Addendum No. 2
October 1, 2021

Project: **Harrisburg Middle School No. 3**
Harrisburg, South Dakota
Architecture Incorporated Project #2903

Architect: Architecture Incorporated

7 ENLARGED PLAN - AREA B KITCHEN - PLUMBING & HEATING

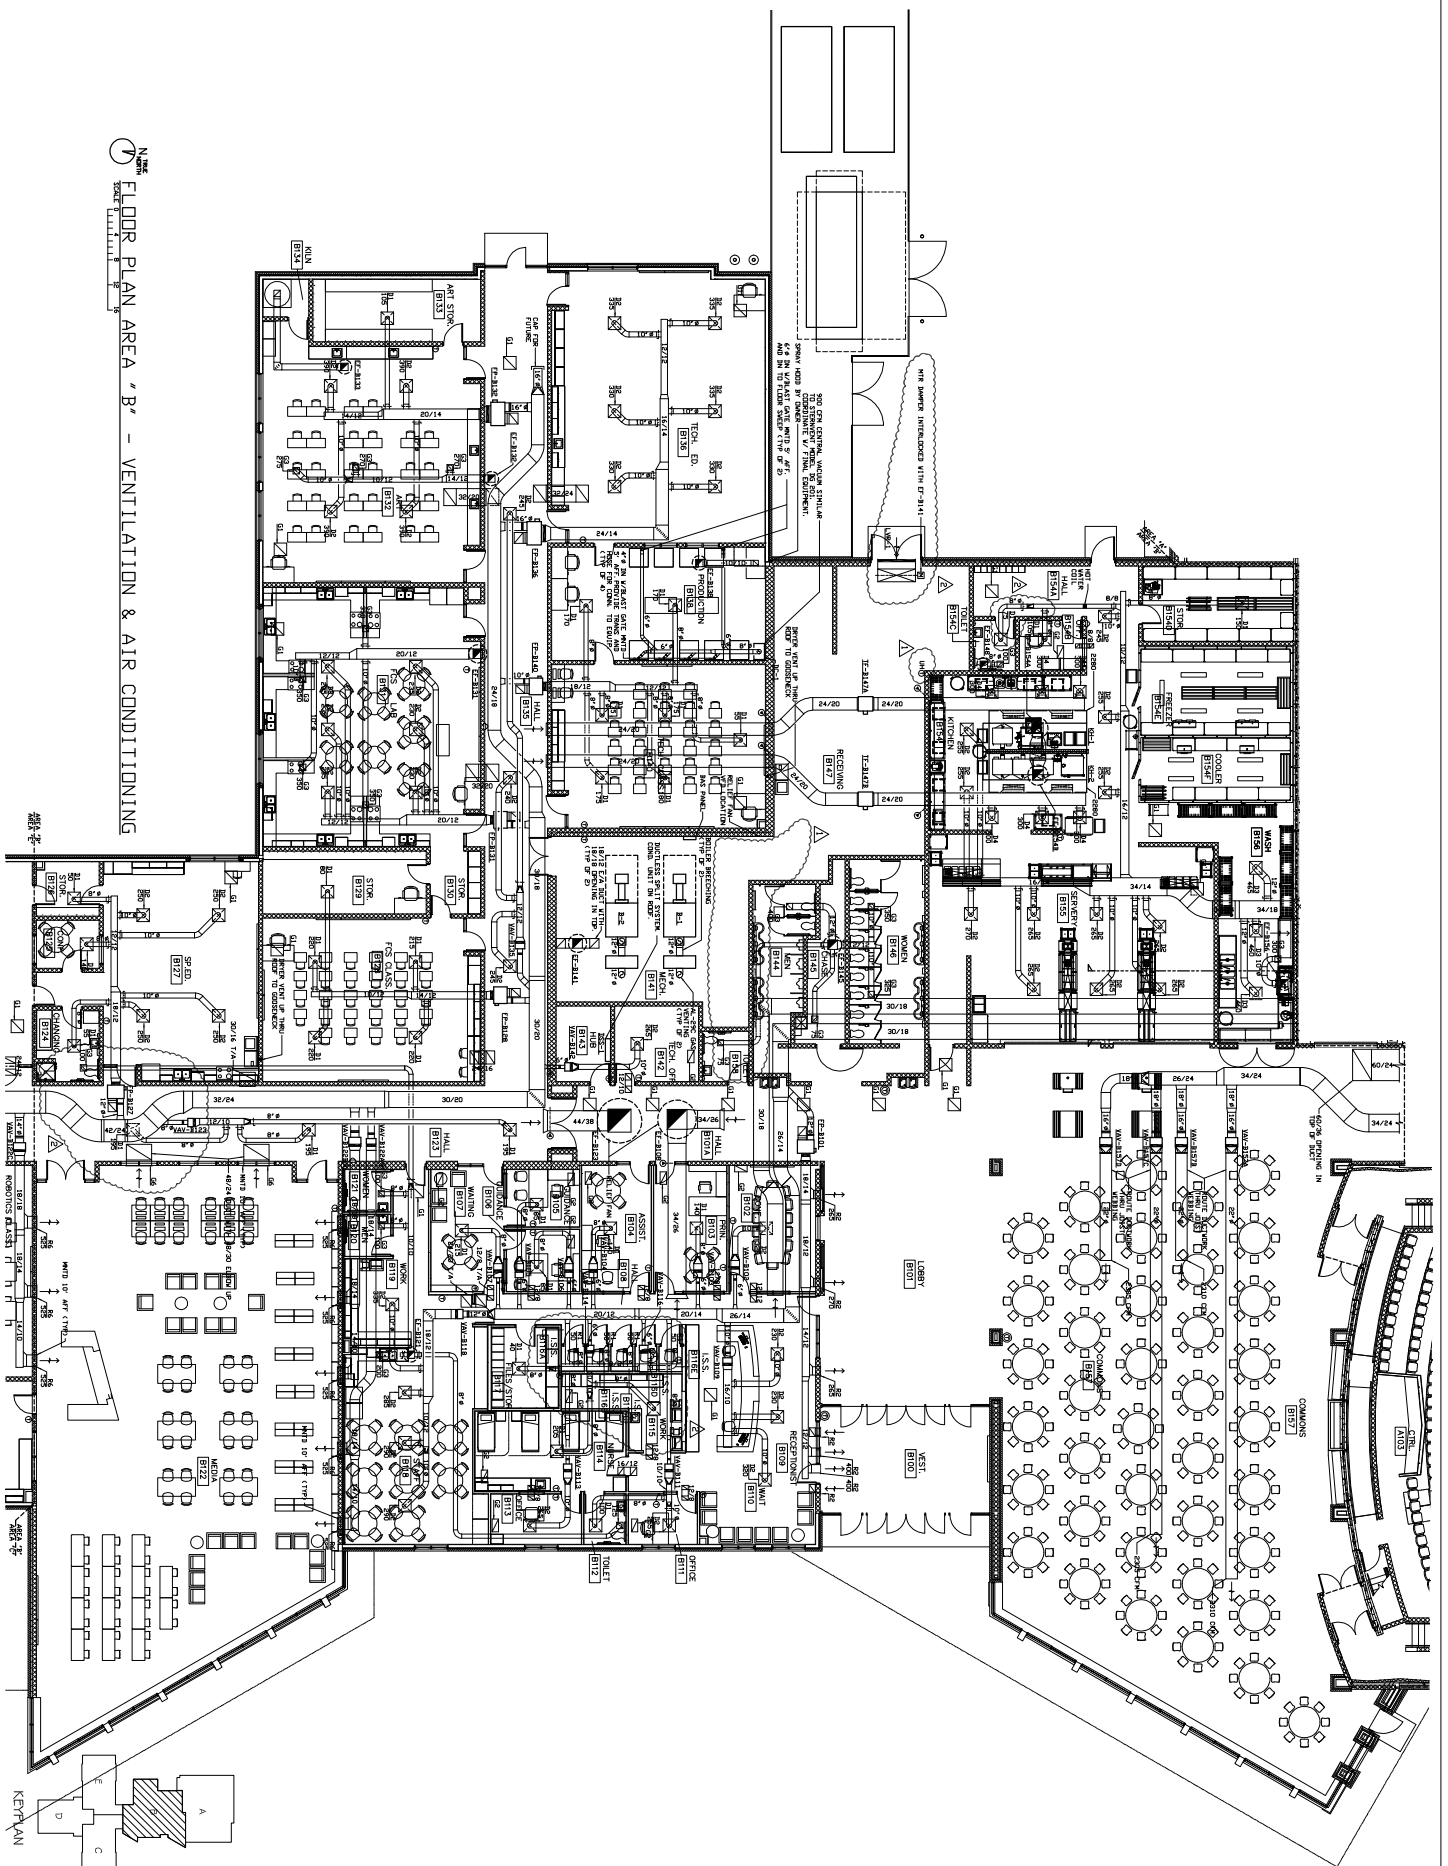
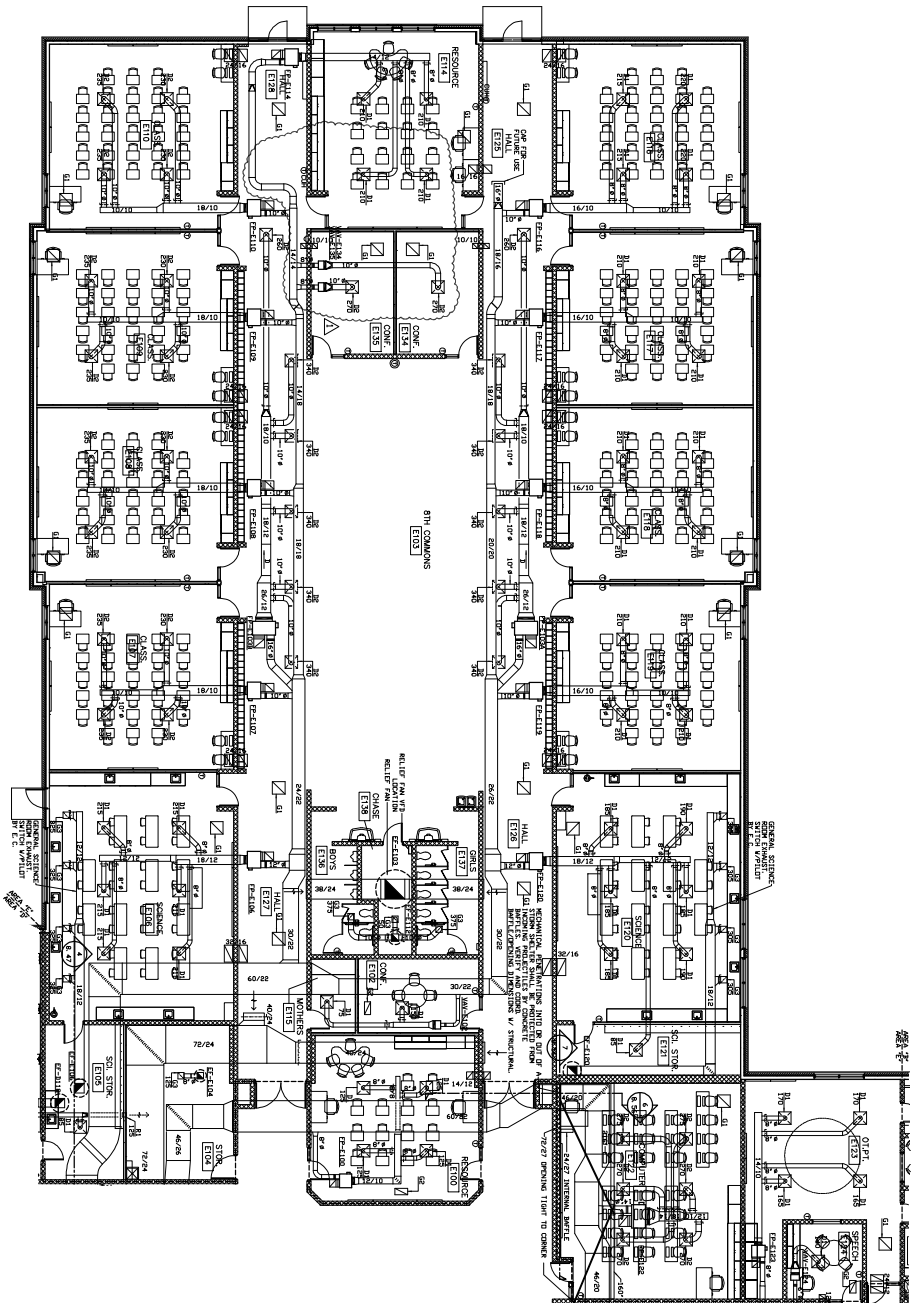
- 15) DRAWING SHEET 8.32 – KITCHEN PLANS – AREA B – PLMBING & HEATING
- a) Provide name of heating coil “HC-B154B” on floor plans. Refer to Revised Drawing Sheet, dated 10-1-21.

- b) Add vent piping from relocated FSK in nearby “Stor B130”. Refer to Revised Drawing Sheet, dated 10-1-21.
 - c) Remove vent piping for eliminated sand-oil interceptor in nearby “Receiving B147”. Refer to Revised Drawing Sheet, dated 10-1-21.
